APS Doney Park Renewable Energy Site

Drainage Report Addendum

June 8, 2011

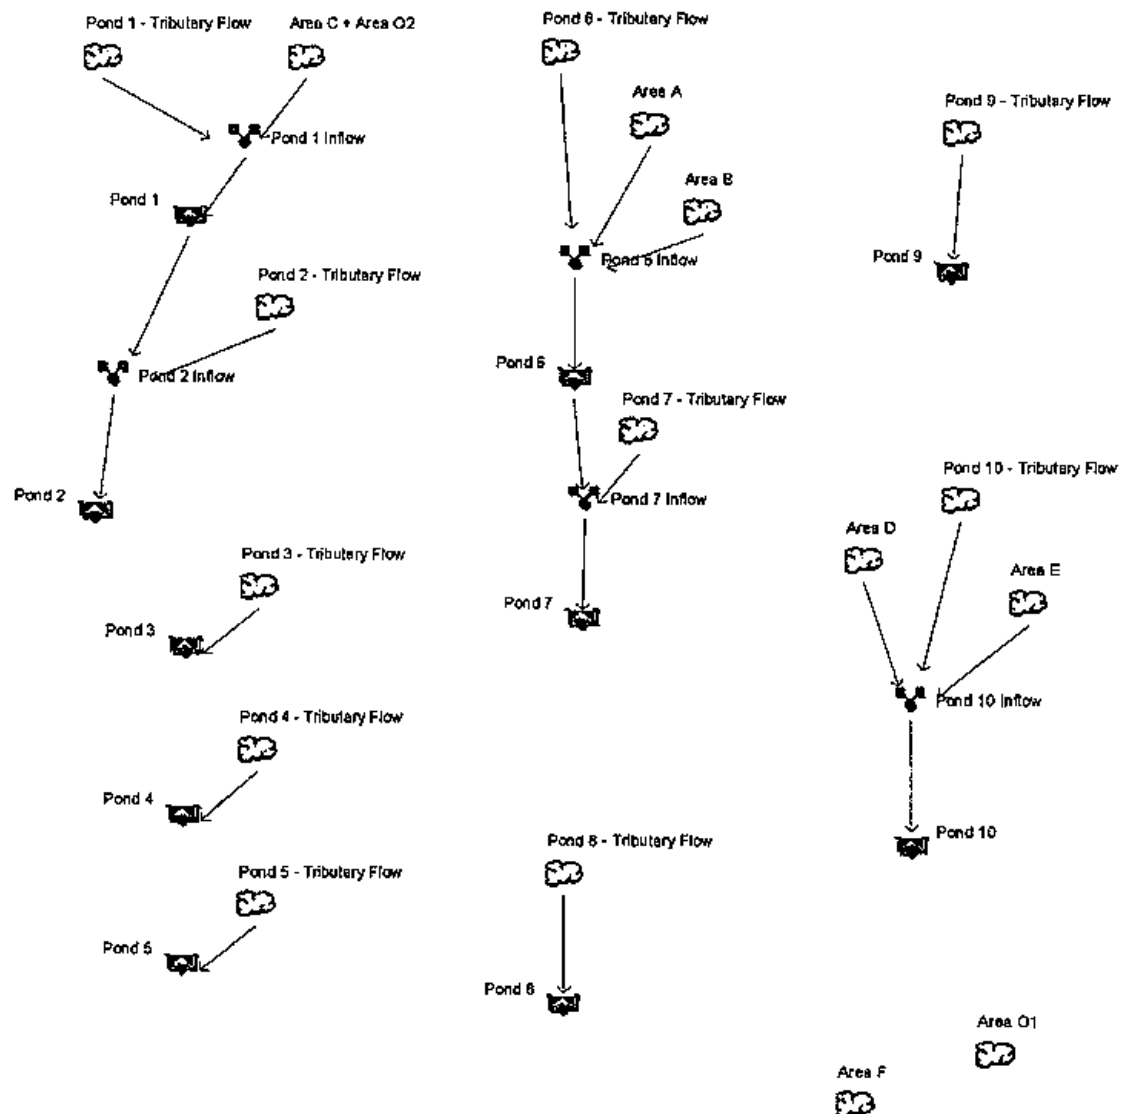
1) The peak weir flows at ponds 1 and 6 for the 100-yr flow condition.

In addressing this question, we discovered a mistake in the model, and fixed the error, which consisted of no interconnection between Ponds 1 & 2. Please see the following model schematic, which illustrates the correct arrangement and relationships amongst all model elements, including the hydrographs, hydrograph additions, and ponds for Ponds 1 & 2.

ALPHA Geotechnical and Materials, Inc. 2504 W. Southern Avenue Tempe, AZ 85282	Double Ring Location Plan	
	Project: Doney Park Renewable Energy Infiltration Testing, 11-G-1903	
	Location: Flagstaff, Arizona	
Date: 05/19/11	Drawn By: J Floyd

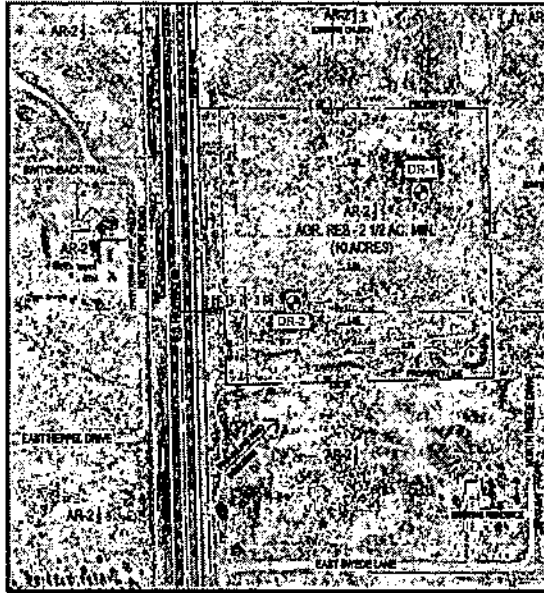
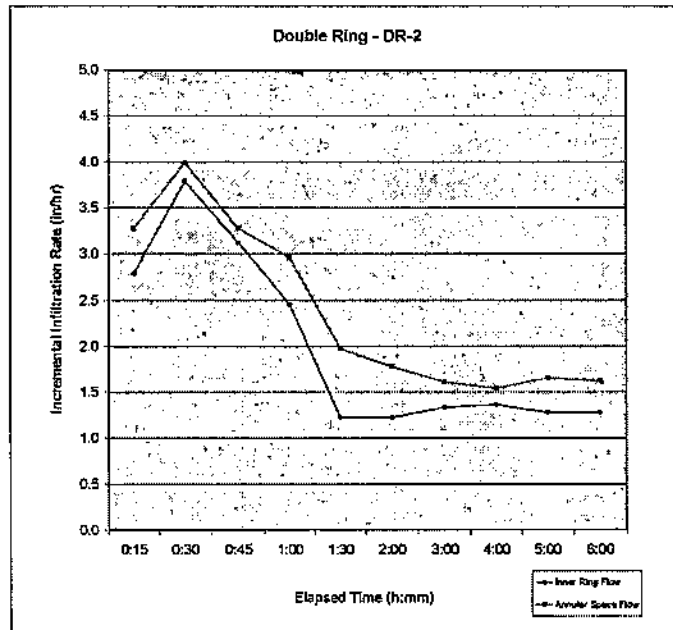
- 3) **As the on-site infiltration tests weren't run in April, the results of the tests may necessitate some drainage report reanalysis if there is measurably lower infiltration capacity determined from the tests. I would like to receive the results of the infiltration tests as soon as they are available.**

On-site infiltration testing was recently completed and the May 19, 2011, Alpha Geotechnical & Materials, Inc. report follows.

The main outcome of the testing is that on-the-ground infiltration rate is 1 in/hr, which is less than the value of 3 in/hr that was used for the April 22, 2011, drainage study.

Therefore, in preparing this addendum, we revised our simulation using the value of 1
in/hr.

Pond 1

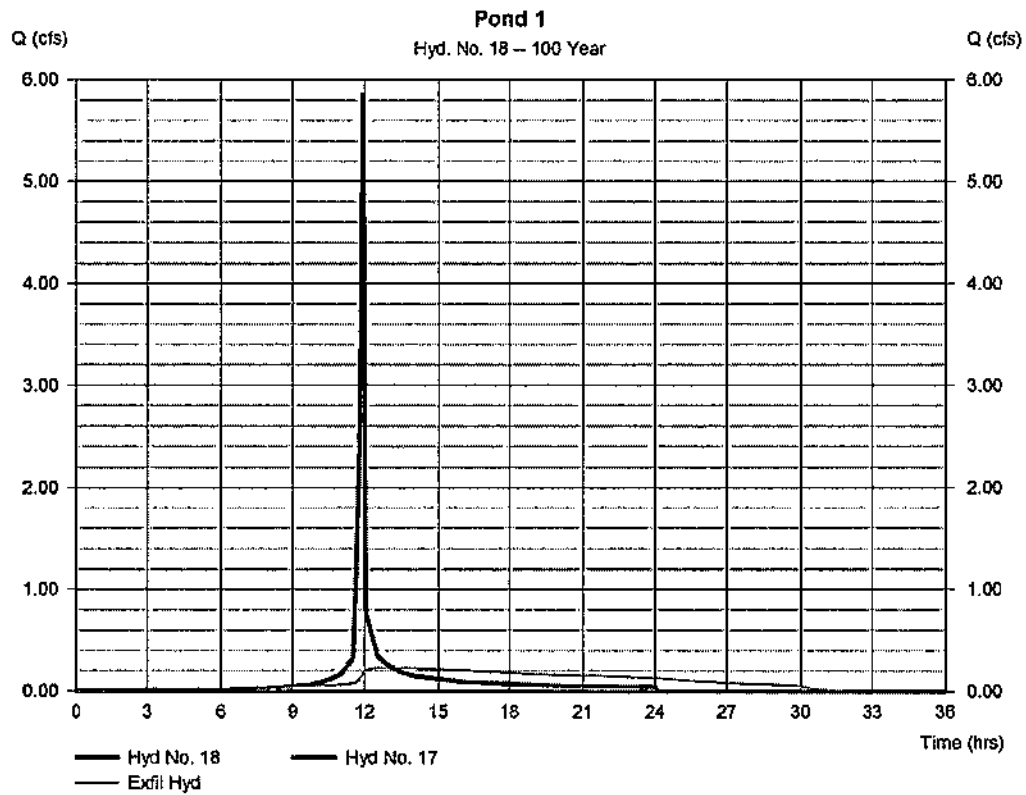
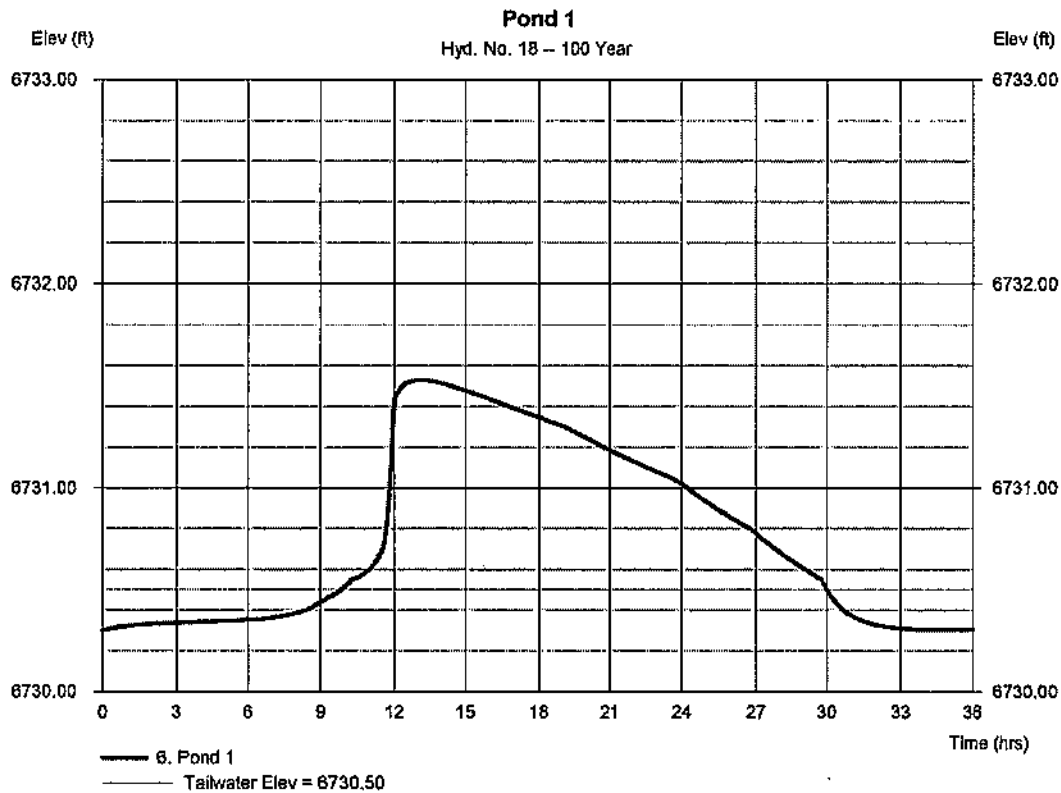
4) Please forward a tabular summary of the infiltration losses versus time for those sites where the graphs were truncated at 14 hrs.

Regrettably, due to a software flaw, whenever a pond has an outflow hydrograph, the display of exfiltration (infiltration) is truncated as soon as the outflow drops to zero, in this case at a time of around 16 hours, for Ponds 1 & 6. However, a worst case scenario is available by disabling the weir outflow for those ponds, which creates a somewhat greater water depth in the pond, but does obtain an acceptable idea as to how exfiltration (infiltration) varies over a 24-hr time period. Please see the following hydrographs (inflow + exfiltration versus time) in addition to graphs of elevation versus time for Ponds 1 & 6 for the condition when no weir is present.

Pond 1

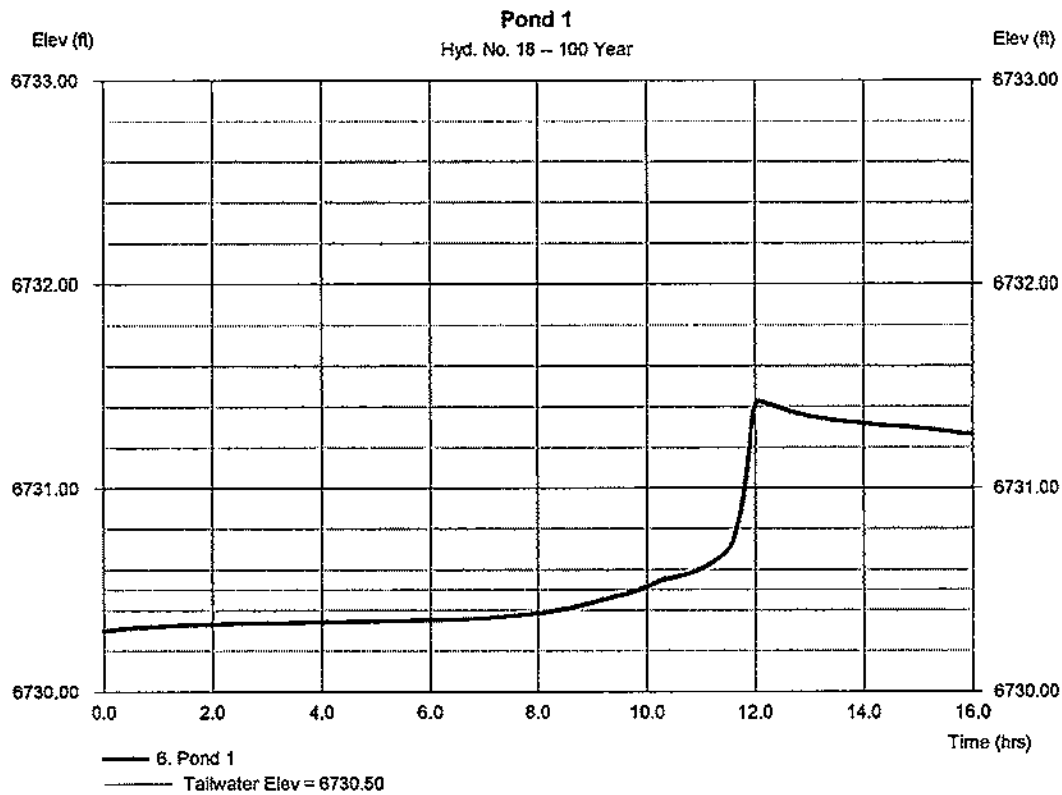
5) Please forward water surface elevation versus time graphs for ponds, especially for ponds 1, 2, 6, 7 and 10.

Graphs of water surface elevation versus time for all ponds 1-10 follow. As discussed above, due to a software flaw, the graphs for ponds 1 & 6 are truncated, as these ponds overflow.
